TRIP REPORT

BASALT WASTE ISOLATION PROJECT

JULY 7 - 18, 1980

STRUCTURES IN A BASALT UNIT

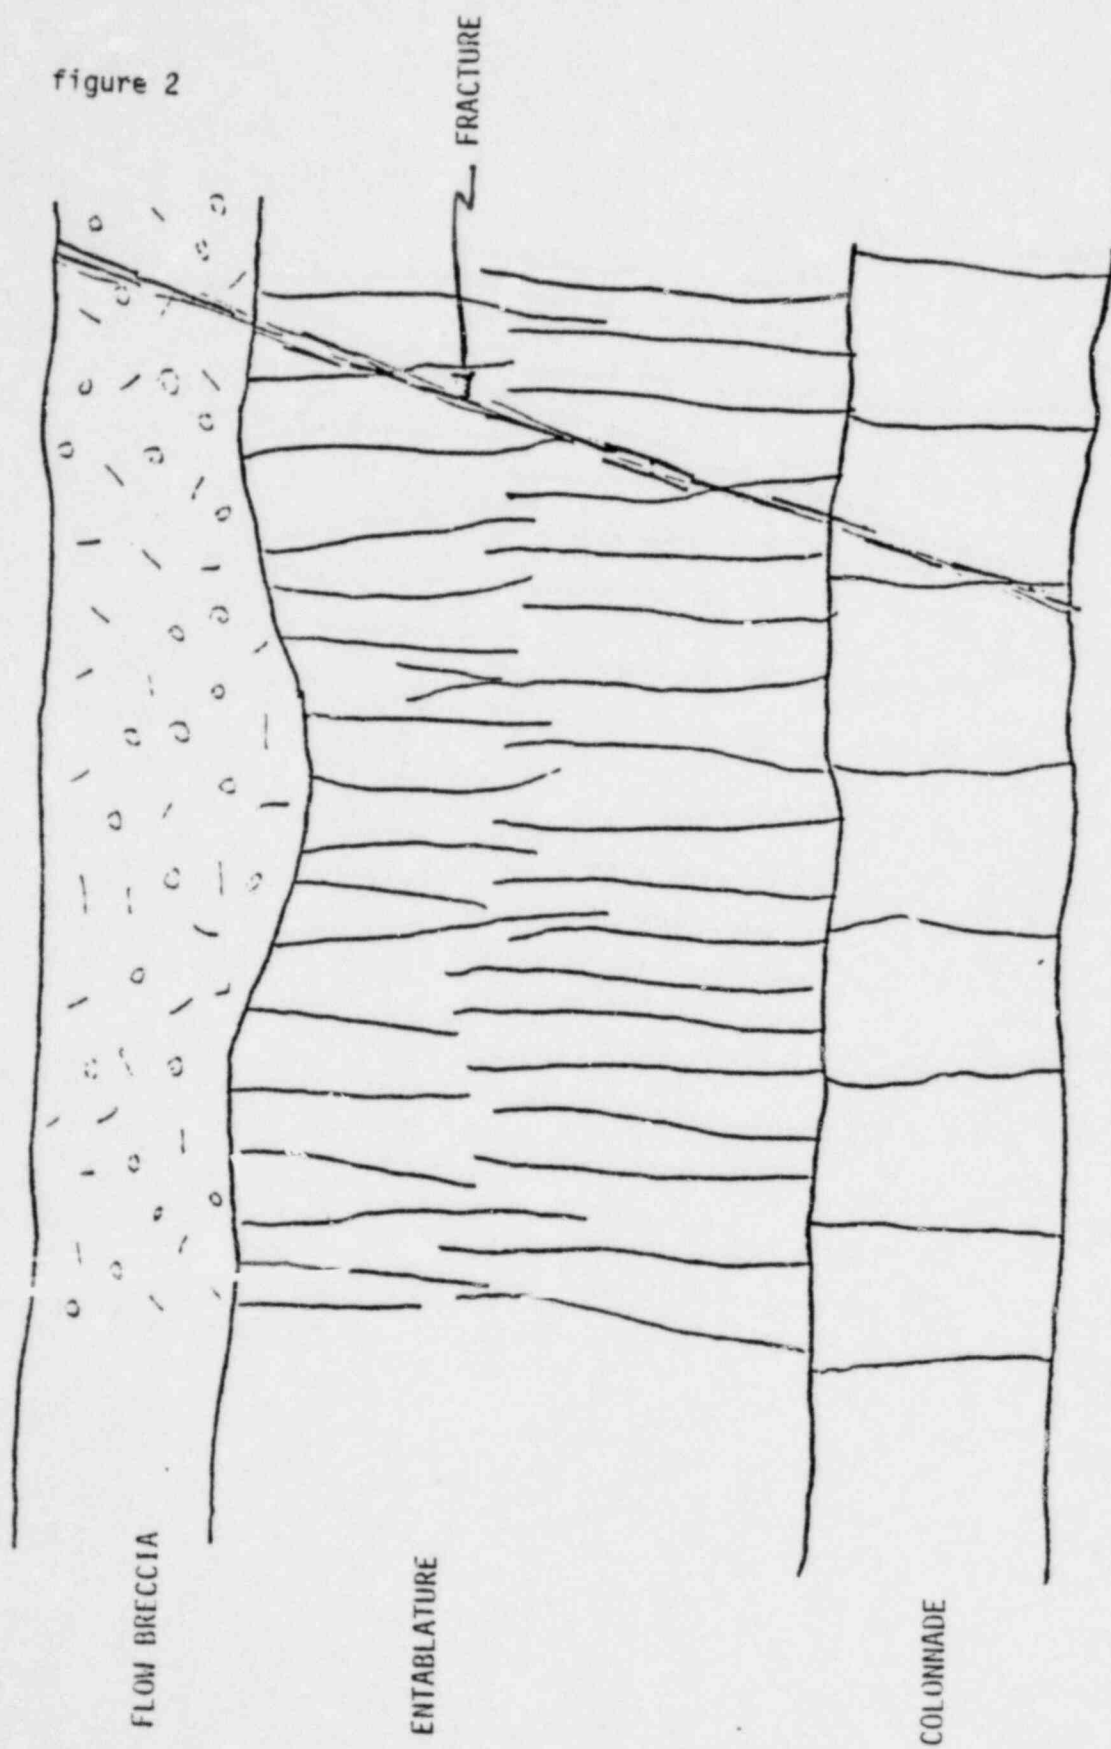
An important feature of a typical basalt flow is the marked contrast in permeability between the uppermost portion of the unit and the central and lowest portions (Figure 2). The upper portion, the "flow breccia zone," comprises up to 30 percent of total flow thickness and is characterized by vesicles (gas holes), breccia and rubble that formed by cracking and movement of the partly hardened crust as the lava moved. This rock is lower in density than average basalt, and the hydraulic conductivity is much higher (on the order of 10^3 times greater) than the hydraulic conductivity of the high density basalt below.

The major technical issue is the need for improved hydrologic testing. Two major concerns related to this issue were identified during the staff visit. Simply stated, these concerns are that all borings currently being drilled and tested are vertical borings which were drilled using mud for circulation. At issue is the ability to perform meaningful hydrologic tests and to collect representative groundwater samples within the colonnade and entablature portions of the basalt in vertical boreholes where there have been few intersections with vertical joints and where the fractures may have been partially or completely sealed by drilling mud.

The borehole should be as free from the effects of drilling as possible. Most notably, this includes the absence of materials coating the borehole walls or sealing fractures in the basalt. In order to optimize the ability to perform hydrologic tests in the boreholes, consideration should be given to drilling without mud and development of the boreholes by high pressure jets or block surging before testing. In addition, the use of multiple borehole deflections is recommended in order to drill inclined holes which will intersect a greater number of joints than in vertical borings. Inclined borings should provide a better opportunity to characterize the fracture systems and to obtain more representative hydraulic conductivities and water samples in the entablature and colonnade portions of the basalt flows.

The hydrologic testing currently being performed in vertical boreholes could also be performed in inclined boreholes. Borehole survey techniques could be used such that inclination and bearing corrections can be applied to measured depths so that stratigraphic depth and thickness correlations can be made. There is a definite need to reevaluate whether vertical borings provide the

In addition, there is a definite need to reevaluate whether the drilling techniques optimize the ability to perform hydrologic testing. Consideration should be given to drilling without mud, particularly in the Umtanum and adjacent basalt flows. Other methods of stabilization, such as maintenance of a positive head in the borehole, should be investigated. In those portions of the borehole where mud is circulated, alternative methods of borehole development, such as the use of high pressure jetting or block surging, should be investigated.
